**SUBJECT:** Elk Hills Project

RE: Elk Hills Project

ELK HILLS PROJECT  
COMMENTS OF THE CITY OF OXNARD  
ON THE DRAFT EIS

Figure 5-1. General Plans of Proposed Alternative Conveyance Systems from Elk Hills Naval Petroleum Reserve.

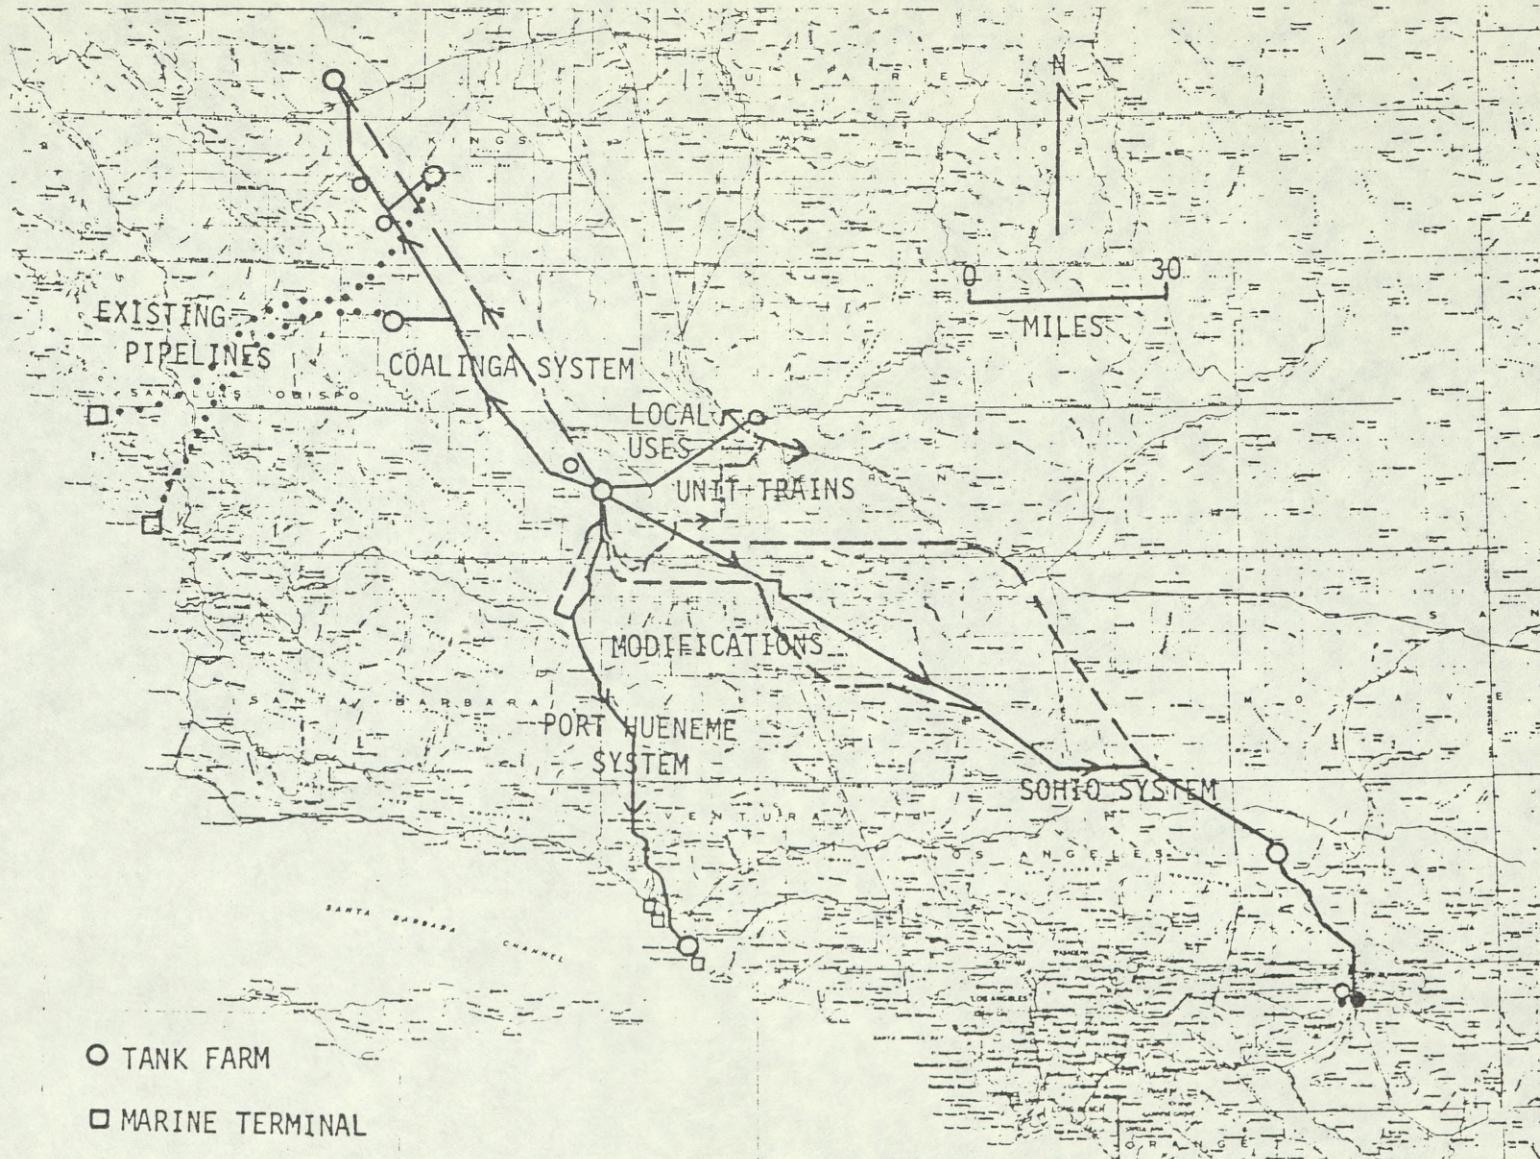
1. The proposed pipeline route from mile 80.0 to 82.5 bisects proposed Tentative Tract 2026-4 and the inland waterways study area in Oxnard, as shown on the attached map. This is a developing marina -residential and water-oriented recreational area of unique character. The presence of the pipeline severely limits the ability of the City to plan and develop this area as a water-oriented resource and is not assessed in the EIS.

1. The proposed pipeline route bisects proposed Tract No. 2026-4 and the inland waterways study area. The presence of the pipeline severely limits the ability of the City to plan and develop this large area as a water oriented resource. It would result in a loss of unique quality development with approximately \$312 million in residential valuation alone.

1. The proposed pipeline route south of Fifth Street is totally inappropriate and should be adjusted so as not to interfere with potential development west of Victoria Avenue.
2. Projected hydrocarbon emissions should be mitigated to insignificant levels.
3. Regulations which will govern the implementation of the project, all mitigation measures, and the activity of oil carriers and contractors should be explained.
4. Unless the implementation of the foregoing three items can be assured, the City of Oxnard opposes the Port Hueneme alternative and recommends that the Navy Department adopt the SOHIO alternative.
